COUNCIL BILL NO. 2016- 102

PURPOSE: To accept the dedication of the public streets and easements as shown on the Preliminary Plat of South Creek Crossing, generally located at 2620 South Campbell Avenue. (Staff recommends that City Council accept the public streets and easements.)

Preliminary Plat - South Creek Crossing

ATTACHMENT 1
BACKGROUND REPORT
PRELIMINARY PLAT – SOUTH CREEK CROSSING

**PRELIMINARY PLAT OF
SOUTH CREEK CROSSING
ALL THAT PART OF THE SOUTHWEST QUARTER SECTION 36, TOWNSHIP 29 NORTH, RANGE 22 WEST
AND THE NORTHWEST QUARTER OF SECTION 1, TOWNSHIP 28 NORTH, RANGE 22 WEST
CITY OF SPRINGFIELD, GREENE COUNTY, MISSOURI**

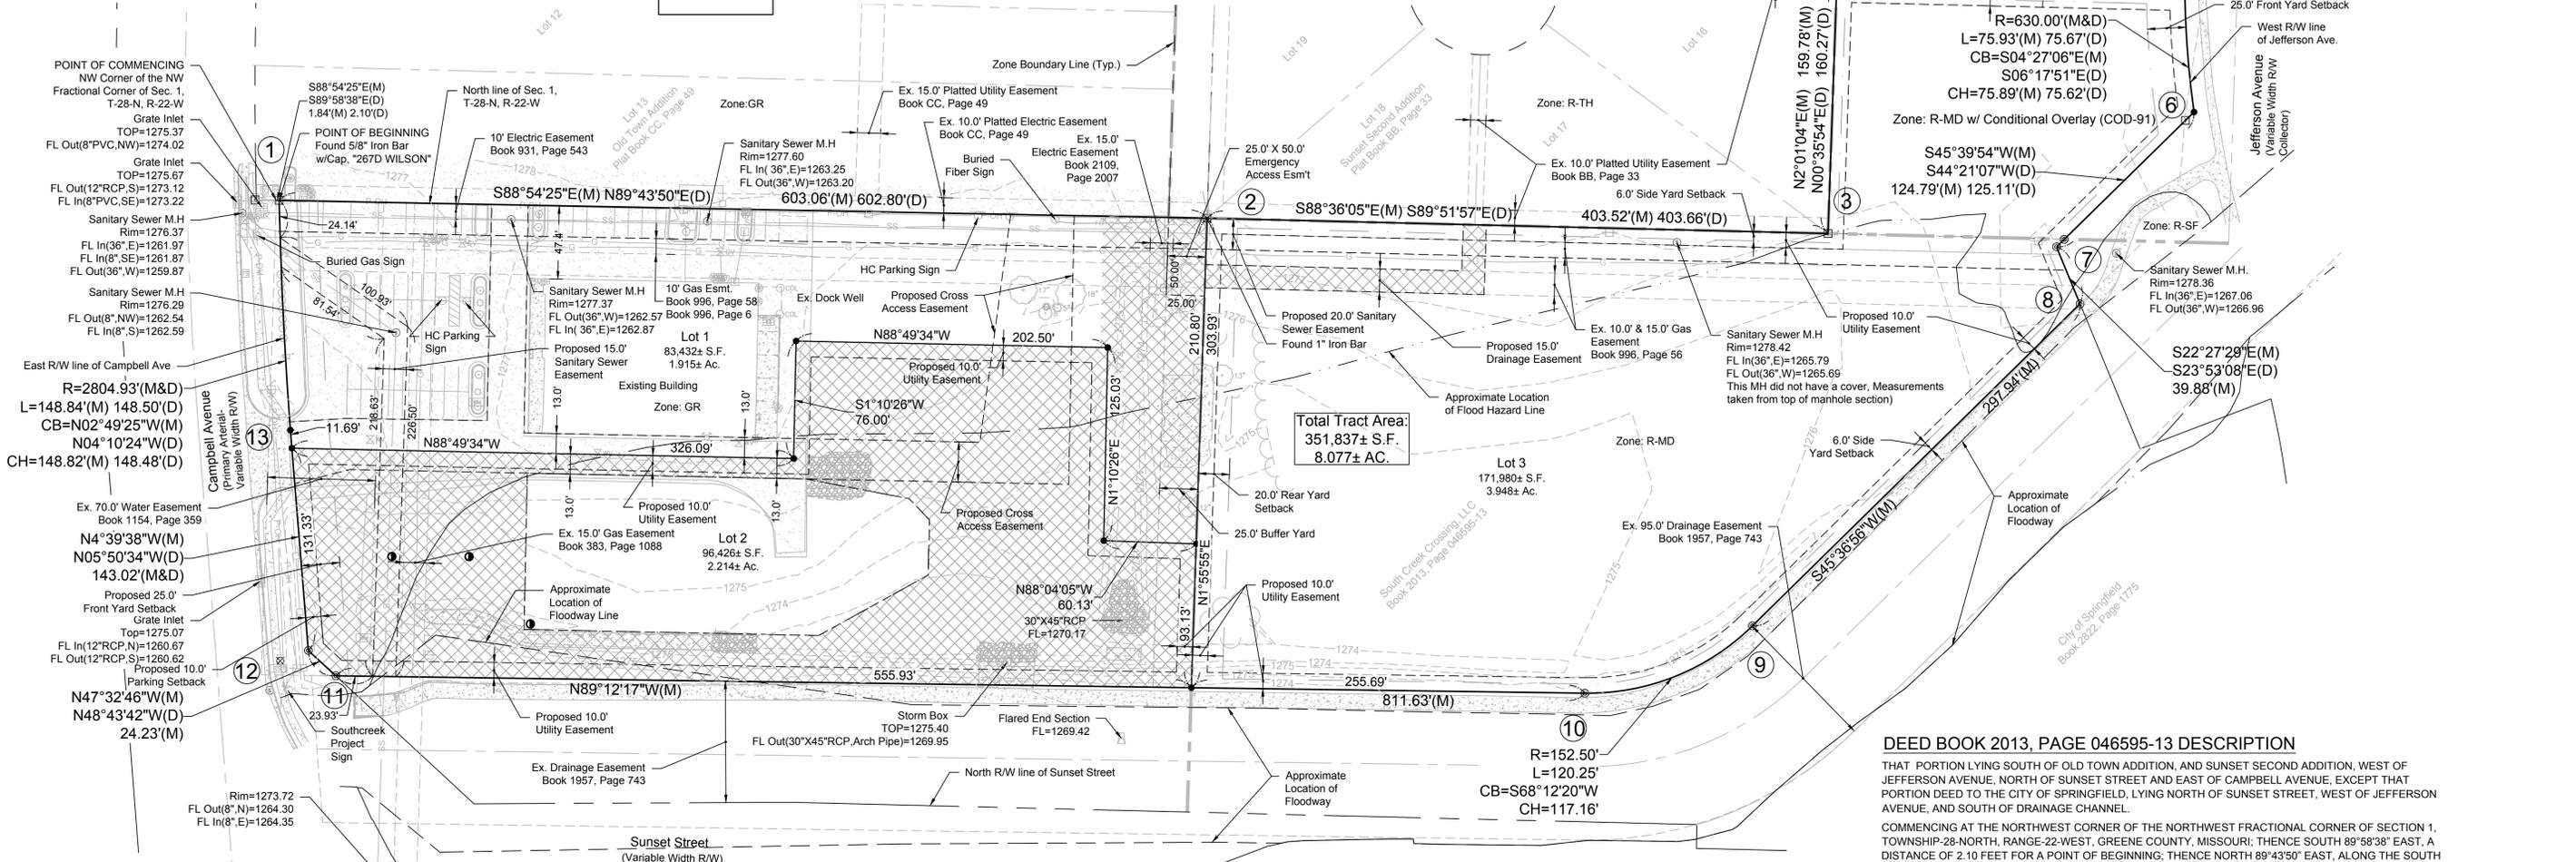
- a. Each lot has access to public sewer although additional public improvement plans will be required for Lot 3 since it is preferred that no lateral connections be made to the trunkline.

- b. Need to dedicate additional sewer easements on the northeast portion of Lot 3. These easements are a condition of the final plat.
 - c. Proposed modifications to the existing water quality basin will require a Public Improvement Plan. Public Improvement Plans will also be required to convey stormwater runoff from South Place through the Sunset Crossing

2. All required street rights-of-way, drainage and utility easements and limitations of access shall be dedicated on the final plat.
 - a. Add a note to the plat stating "No access is allowed to Sunset Street per Special Ordinance 24398.". No additional access allowed to Campbell Avenue.

Add 10 foot utility easements around all perimeters of lots 2 & 3 for AT&T facilities.

1. No additional access allowed to Campbell. Must utilize existing shared access with property to the north.
2. Add a note to the plat stating "No access is allowed to Sunset Street per City Ordinance 24398."

Since the site is located in the floodplain, stormwater detention has been bought-out for Lots 1 & 2 and will be bought-out for Lot 3 at the time of development. A regional water quality basin has been constructed to serve Lots 1, 2 & 3 under Public Improvement Plan 2015PW0002. Proposed modifications to the existing water quality basin will require a Public Improvement Plan. Public Improvement Plans will also be required to convey stormwater runoff from South Place through the Sunset Crossing Subdivision to South Creek. Public Improvement Plans will need to be constructed or escrowed prior to final plat approval or issuance of a building permit. All required drainage easements and topography is shown.

1. Each lot has access to public sewer although additional public improvement plans will be required for Lot 3 since we prefer that no lateral connections be made to the trunkline.
2. Need to dedicate additional sewer easements on the northeast portion of Lot 3 as shown on the changemarks. These easements are a condition of the final plat. The preliminary plat approval is conditional based upon these easements being added to the final plat.
